| APPLICATION NO. | FILING DATE | FIRST NAMED INVENTOR | ATTORNEY DOCKET NO. | CONFIRMATION NO. |
|-----------------|-------------|----------------------|---------------------|------------------|
| 10/042,998 | 04/12/2002 | David N. Armstrong | 10148-1020 | 6172 |

| Advisory Action Before the Filing of an Appeal Brief | Application No. 10/042,998 | Applicant(s) ARMSTRONG, DAVID N. | |

THE REPLY FILED 28 January 2005 FAILS TO PLACE THIS APPLICATION IN CONDITION FOR ALLOWANCE.

FIG. 7

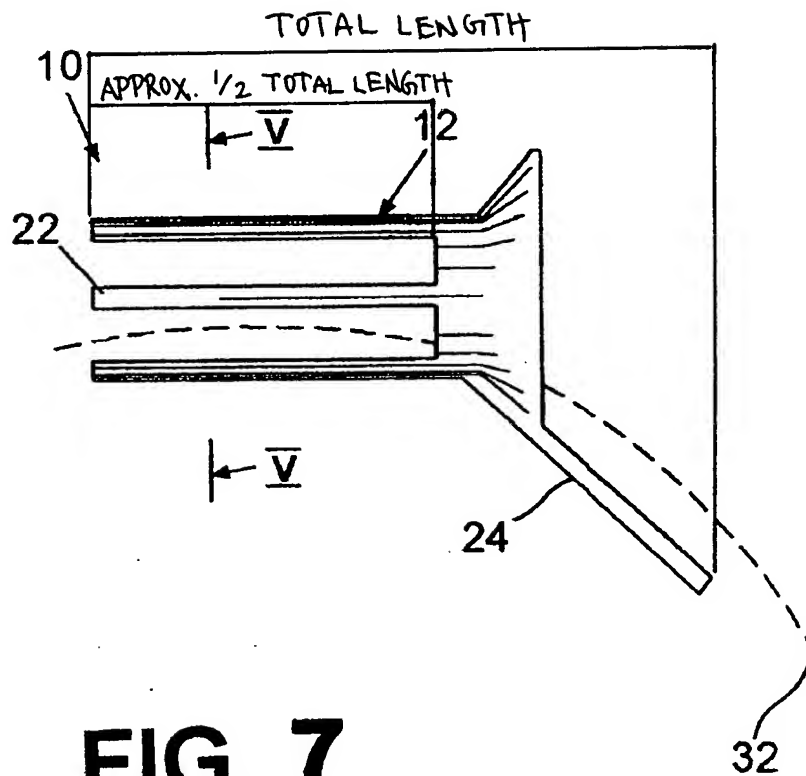
Continuation of 11. does NOT place the application in condition for allowance because: The Applicant argued that Bayer does not disclose the anoscope having openings at three o'clock, seven o'clock, and eleven o'clock positions. However, Bayer teaches an anoscope with multiple openings as shown in figures 4 and 5. Figure 5 shows the spatial relationship of the holes. The anoscope of Bayer reads on the claim limitation because it can be placed in a position that would place the holes or part of the holes in the positions of three o'clock, seven o'clock, and eleven o'clock positions as shown in the drawing section of the Final Rejection. The Applicant also argues that Bayer does not teach that the openings being halfway along the length of the anoscope. The as shown in the included drawings page; Bayer meets the requirements.
